New Escambia County Jail Correctional Facility Design Criteria Package

DBE Proposals – Technical Analysis

The New Escambia County Correctional Facility
DBE Submittal Technical Evaluation

Functional Evaluation of Proposal

Functional/Operational Impact Summary - Caddell

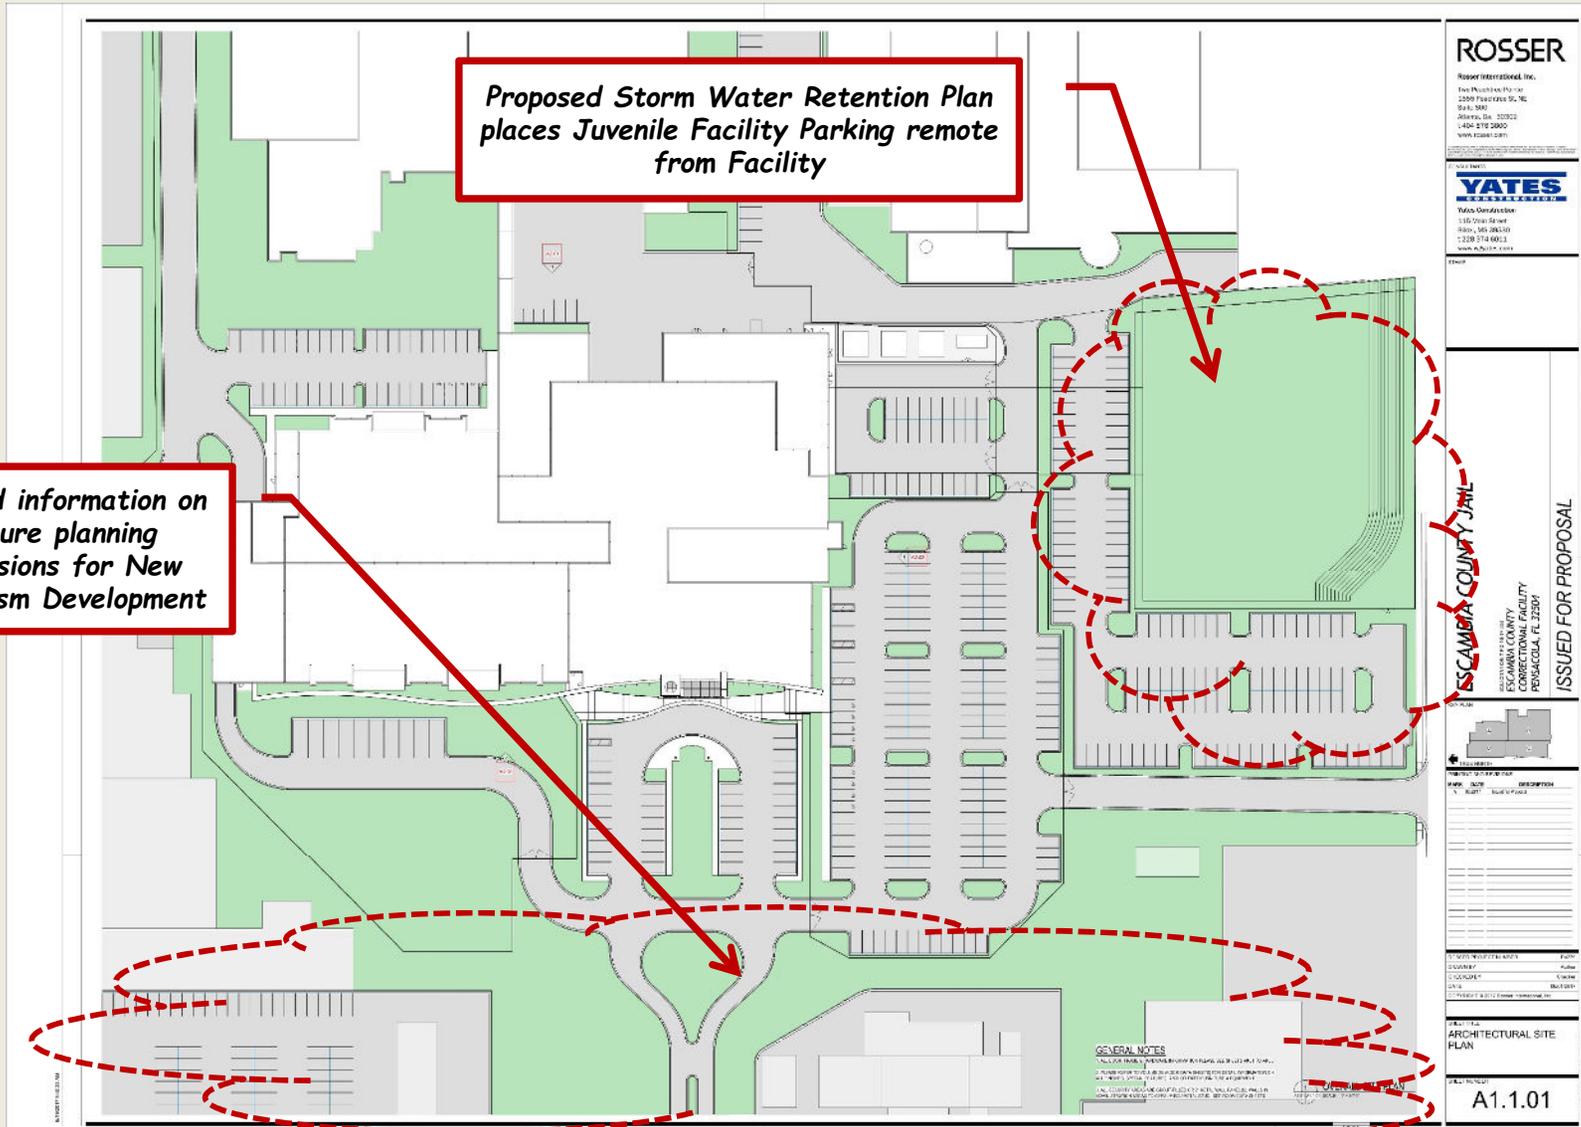
All other aspects of the blocking and stacking/functional organization of the Design Criteria have been maintained including:

- Adjacency of High Security Housing and Reception Housing to Intake for reduced movement and staff response;
- Basic housing floor plate of five units - 2 cells and 3 dorms, 320 beds – per level in Phase 1 maintained for unit management and staffing efficiencies
- Staff/professional visitor elevators to all floors maintained along with attorney visiting on the floor accessed from elevator;
- Actual corridors or structure provided to accommodate extension of corridors for future expansion to the east;
- Maintains overall building height at 3 housing floors (6 levels)

First Floor - Yates

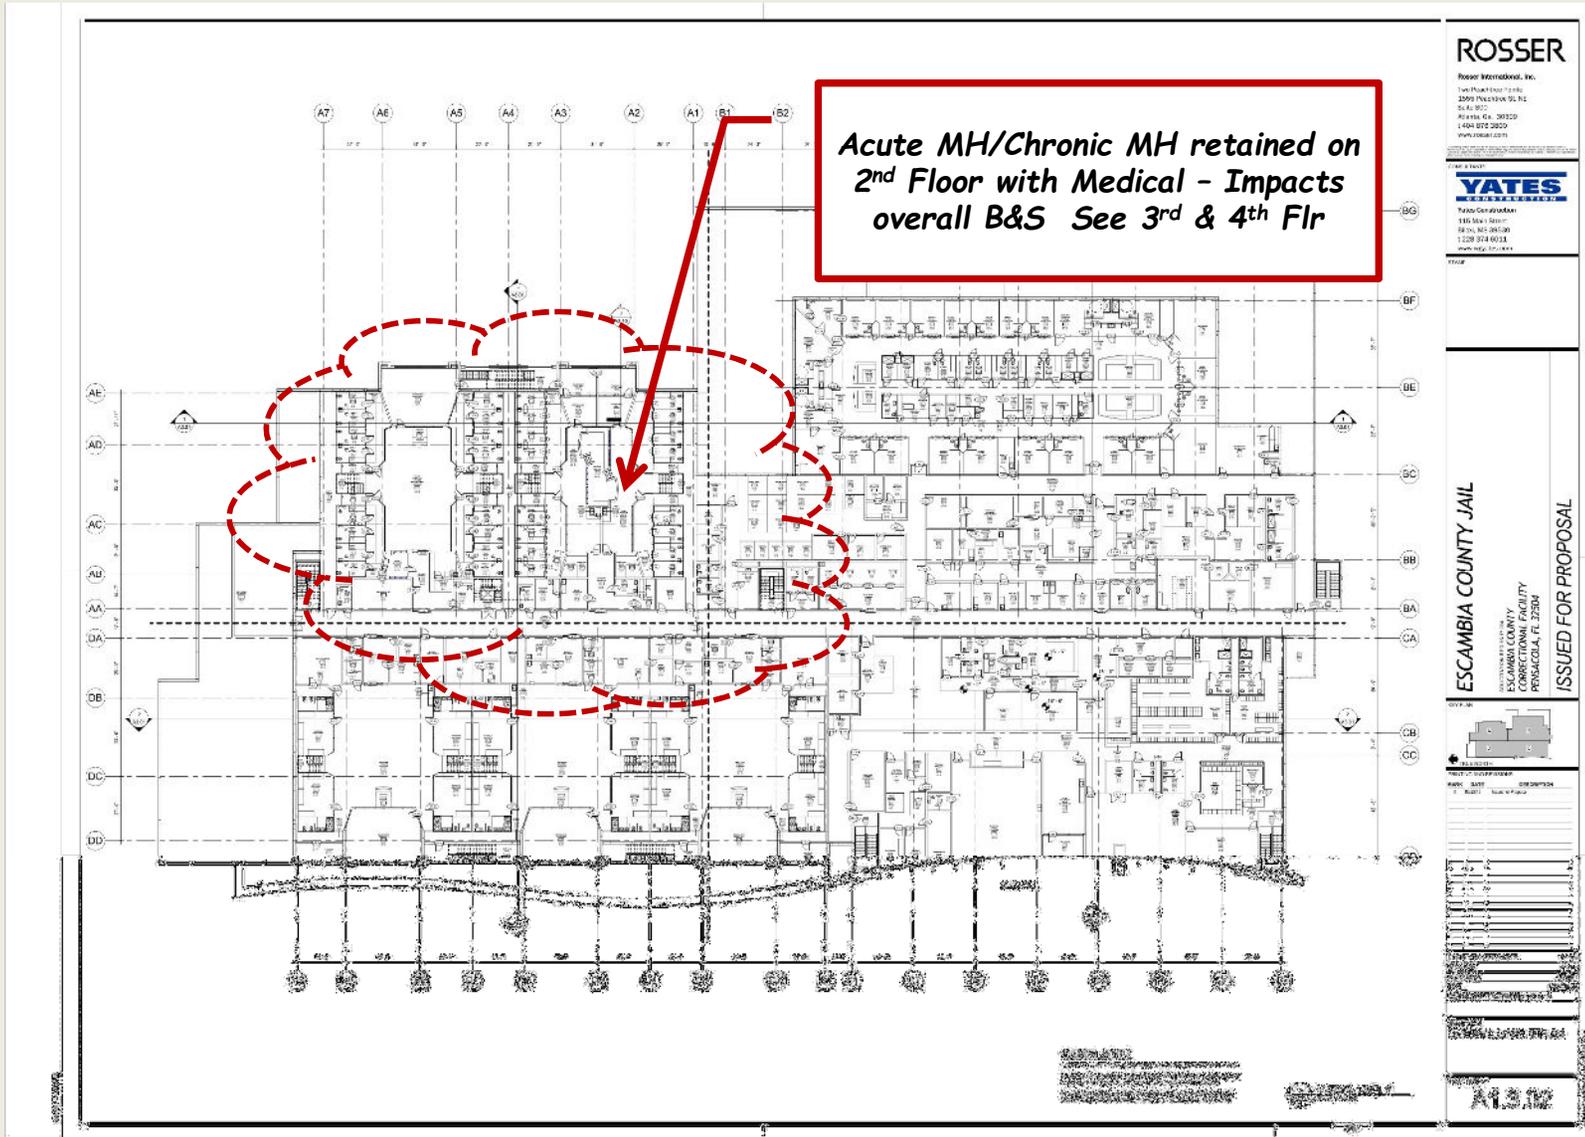
- Juvenile Housing Relocated to First Floor to reduce building volume:**
- High Security & Reception housing moved to upper Floor - Potential Operational & Staffing Impact for increased & High Security Movement
 - Intake/Transfer/Release staff no longer part of immediate response team
 - Quality of Environment for Juvenile Housing Diminished - More Institutional/Jail like (Elimination of windows in cells, dayroom proportion, clerestory lighting, outdoor exercise open to the sky)
 - Significant Impact on Facility when Juveniles moved to Medical
 - Juvenile now located near highest traffic area

Third Floor - Yates

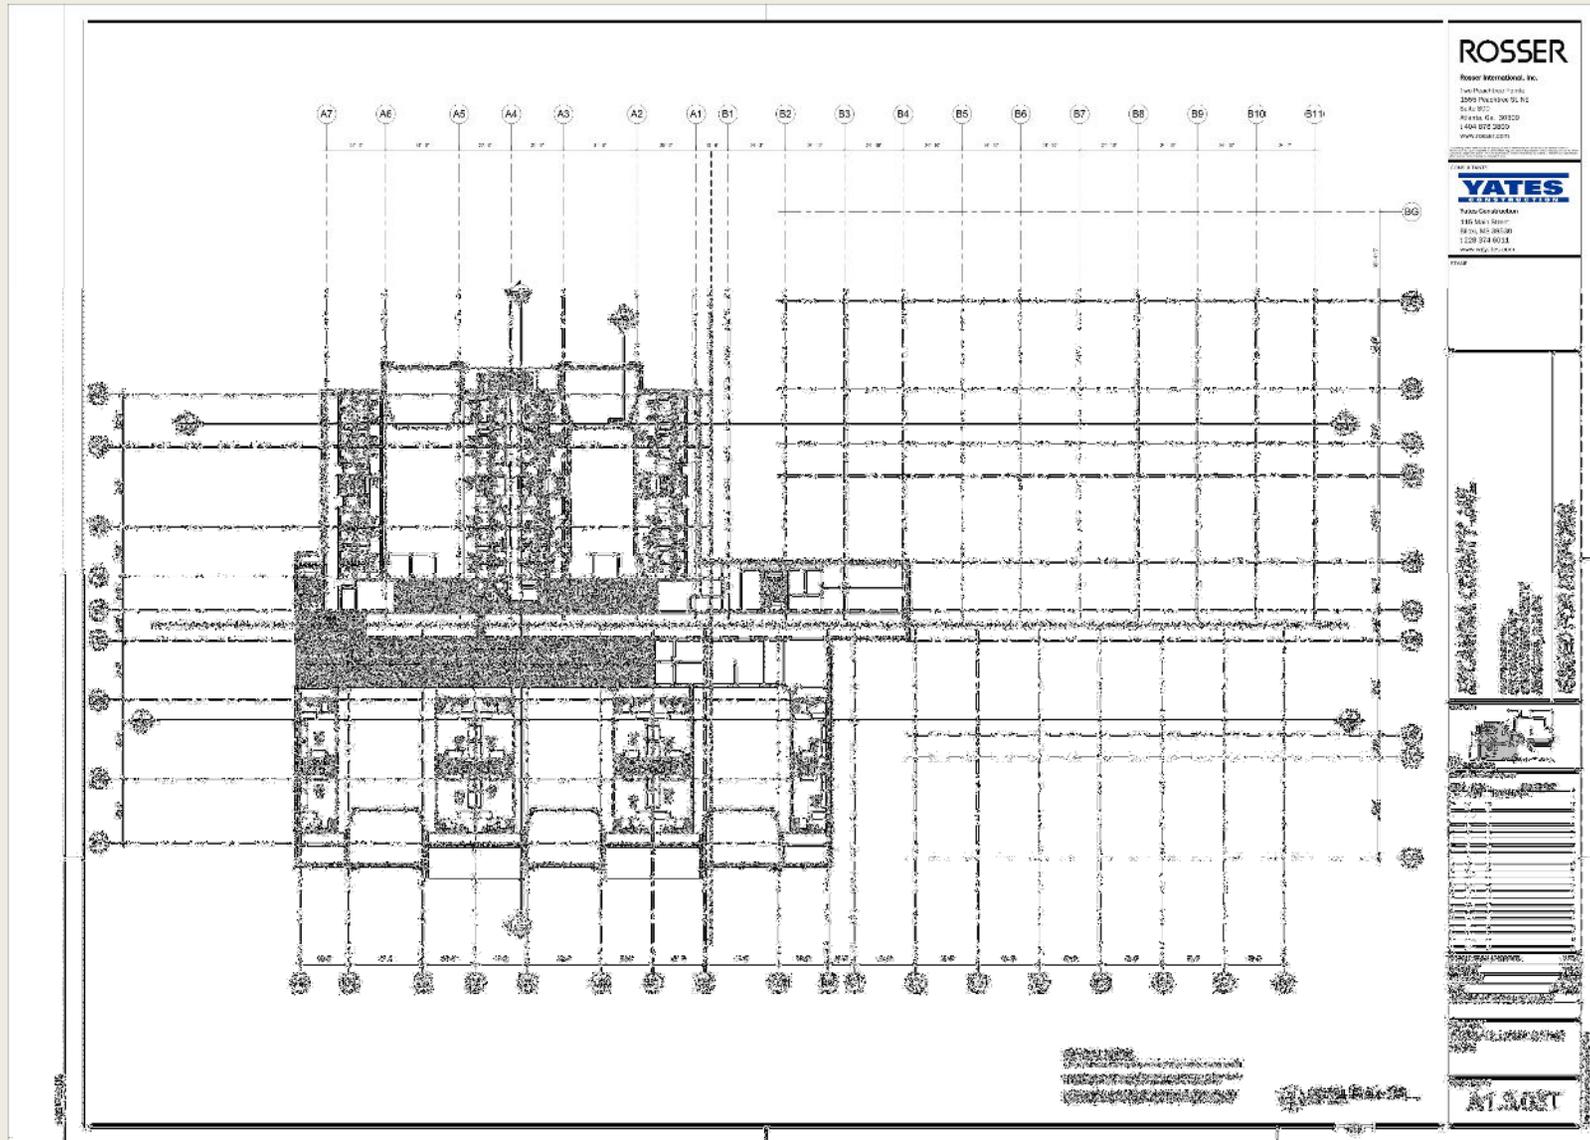
No provisions for future Expansion to the East; Mechanical Room located where Corridor would be needed

The proposed Block and Stack does not make any provisions for future expansion and in fact the mechanical room on the third floor is in direct conflict with a corridor location for expansion to the East.

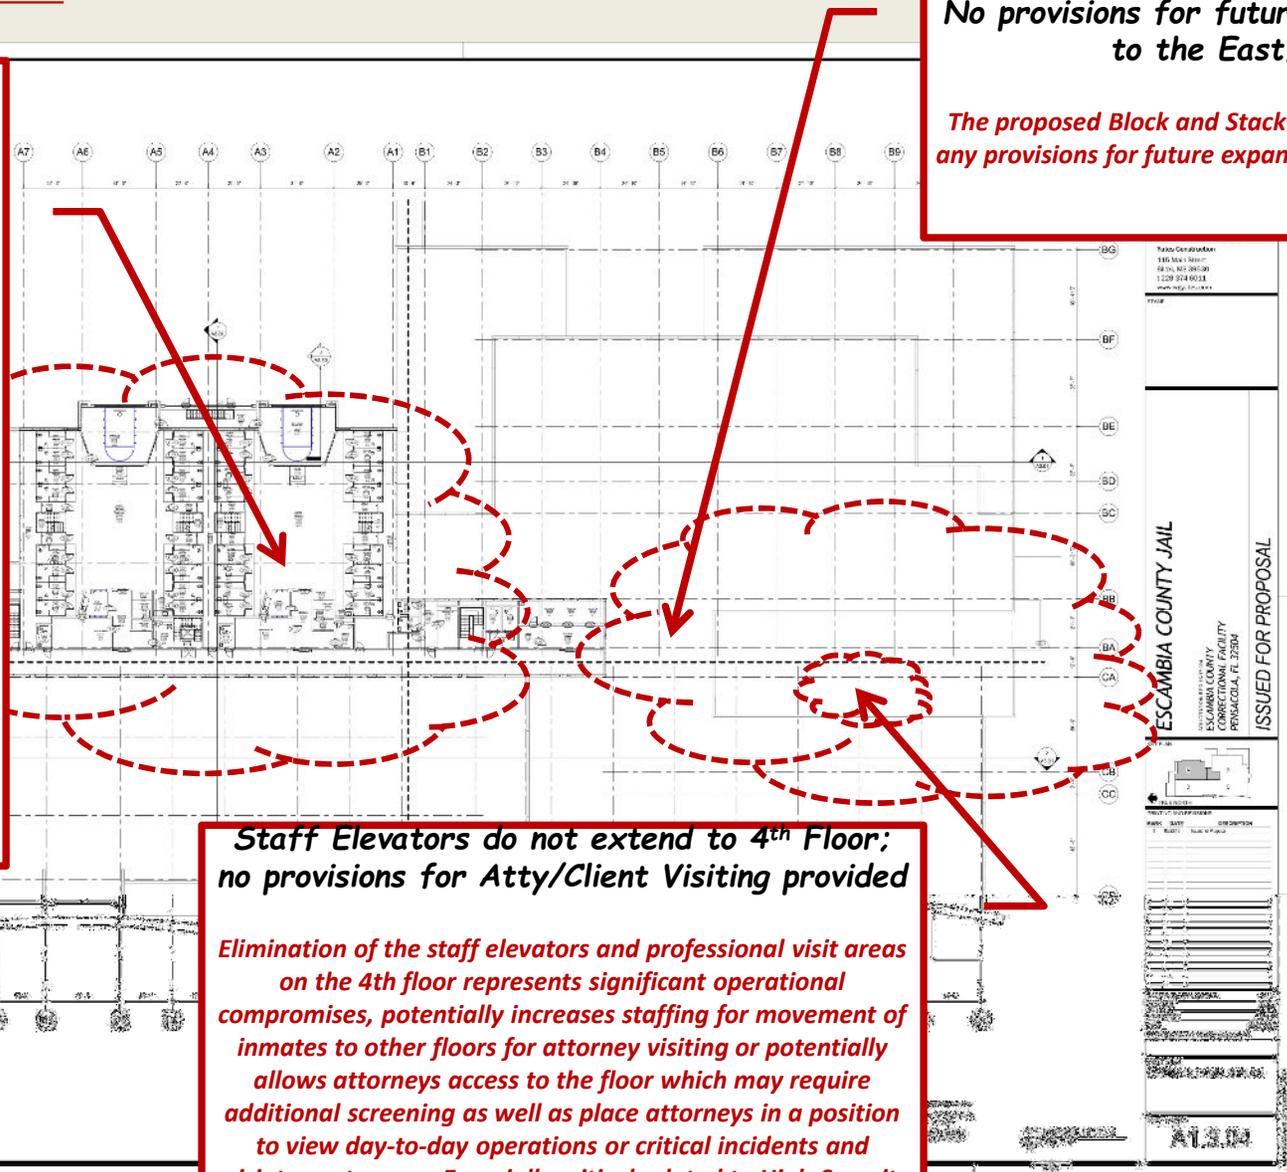
Results in two units isolated on 4th floor

- Conflicts with creating 320/future 640 bed management units
- Limited availability of emergency response staffing & Increased movement will result in increased staffing;
- If one floor still desired for females, places High-Security and Reception at greatest distance from Intake/Transfer, Arraignment Courts and Release

Revising the blocking and stacking/functional organization as proposed is believed to result in significant functional and operational compromises and will result in increased due to the isolation of two housing units on the fourth level with no adjacent support functions;

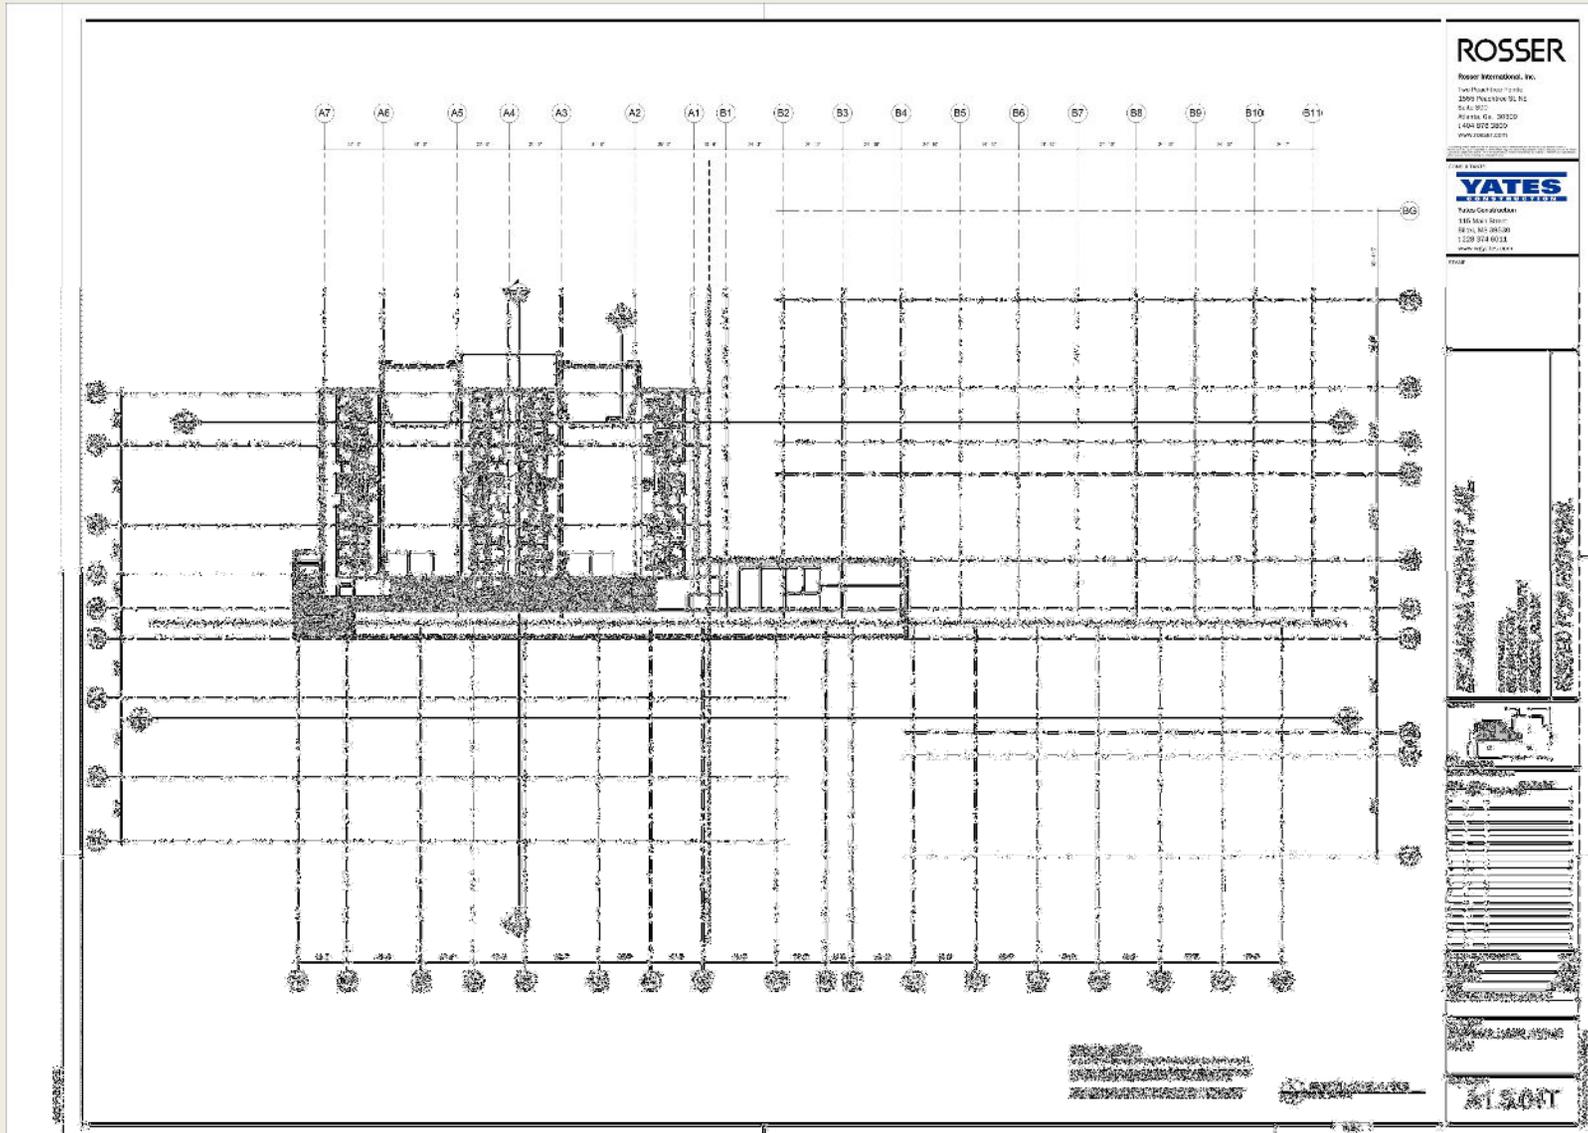
Staff Elevators do not extend to 4th Floor; no provisions for Atty/Client Visiting provided

Elimination of the staff elevators and professional visit areas on the 4th floor represents significant operational compromises, potentially increases staffing for movement of inmates to other floors for attorney visiting or potentially allows attorneys access to the floor which may require additional screening as well as place attorneys in a position to view day-to-day operations or critical incidents and misinterpret same; Especially critical related to High-Security & Reception Housing if provided on 4th floor;
